Manor Farm Options summary

Prepared for Stuart Mee

Figure 1: Map of the current abstraction system with proposed LTC road shown as dashed grey line.

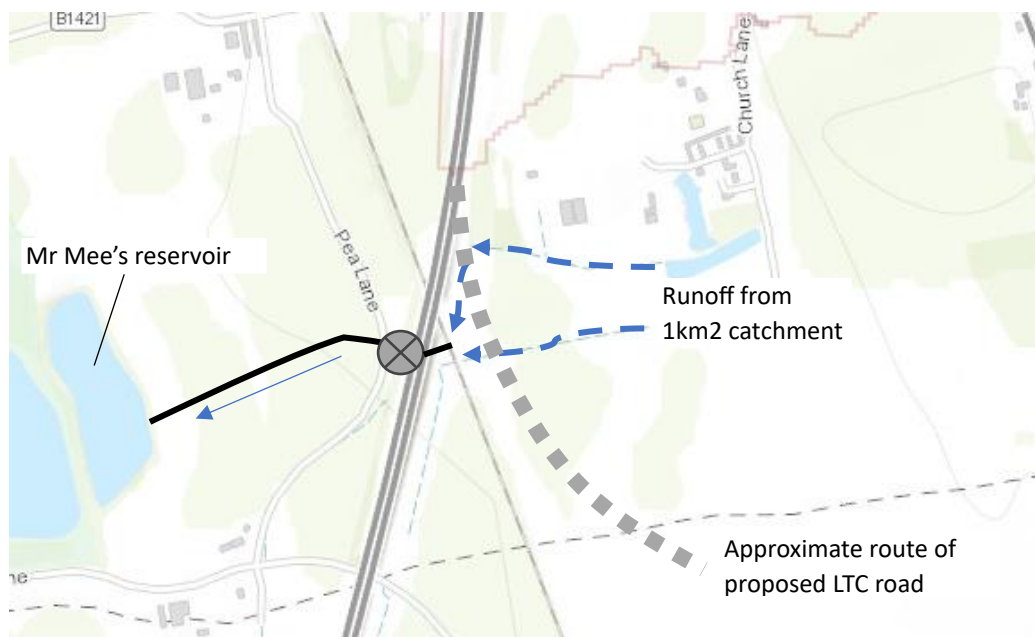
As you can see from Figure 1, the proposed new road cuts directly through the current system and has the potential to change the hydrology of the area just upstream of Mr Mee's abstraction point. The cutting for the proposed link road will re-route catchment flows and

cut off the source of supply. It will also sever the irrigation main which carries water back under the M25 to supply the main agricultural area of the farm.

We are also concerned that the cutting will act as a hydraulic sump, intercepting shallow groundwater and routing it away from the existing drain and into new drainage structures which will be constructed to protect the road.

Without appropriate mitigation we believe that the roadworks could cause a 100% loss to Mr Mee's irrigation supply. Furthermore, the irrigation main will be severed separating the current storage facility from the greater part of the farm.

Figure 2: LTC plan showing proposed land drainage and irrigation solution

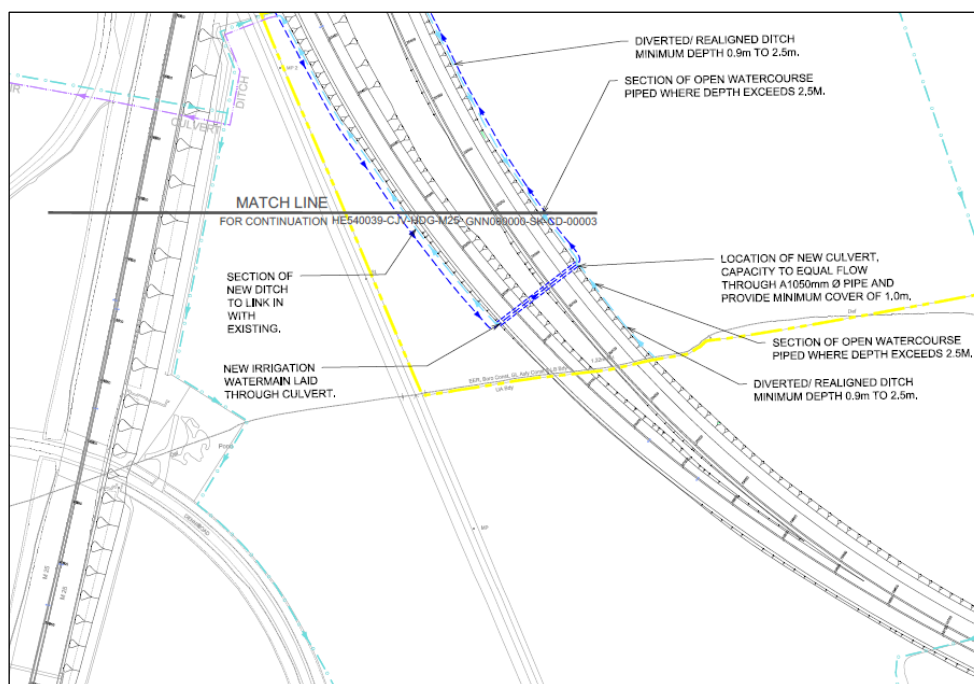
LTC have proposed to re-route the drain to the south, as shown by the blue dashed line in Figure 2 below. This involves constructing approximately 500m of new drainage ditch along both sides of the new cutting.

As part of developing their proposal LTC collected data on the flows into Mr Mee's reservoir and attempted to model the hydrology of the catchment. However, our confidence in the flow data is very low, due to complications with the monitoring equipment. LTC have acknowledged this. This also means that the modelling work, which was based on the same flow data is potentially inaccurate.

We are concerned that by re-routing the drain there may be an insufficient hydraulic gradient to ensure that a flow of water can be maintained. We are also concerned that the steep hydraulic groundwater gradient, which would be induced by the new cutting, will increase the risk of the loss of water from the base of the drain and into any new drainage structures constructed as part of the roadworks. This is likely to occur even if the new cutting is partly tanked.

The footprint of the new link road represents a significant proportion of the catchment area supplying Mr Mee's abstraction. We are concerned that the new roads will intercept rainfall and reduce recharge and storage capacity within the catchment and re-route water away from current flow paths reducing the potential yield at Mr Mees abstraction point.

In addition, we have no confidence in the data collected by LTC to support their proposal.

We are proposing the following solution to provide Mr Mee with a like-for-like abstraction system that has the same volumes and reliability of supply as his current system (see Figure 3). It included two elements:

The option that will maintain the highest proportion of Mr Mee's current abstraction supply, is to pump the water from one side of the new road to the other. Water would be captured in an abstraction sump to the east of the road and then pumped under the road and into the existing pipework before entering the reservoir. The same pipe will also be used to re-instate the irrigation main which carries water back under the M25 to supply the fields on the east of the M25.

The re-instatement element will not provide the same volumes of water as the current system. Therefore, we propose to make up the difference by increasing the abstraction rights on a licence at Kemps Farm or developing a new chalk borehole abstraction. Both these options are being discussed with the Environment Agency. Initial discussions suggest that one or both additional sources may be available.
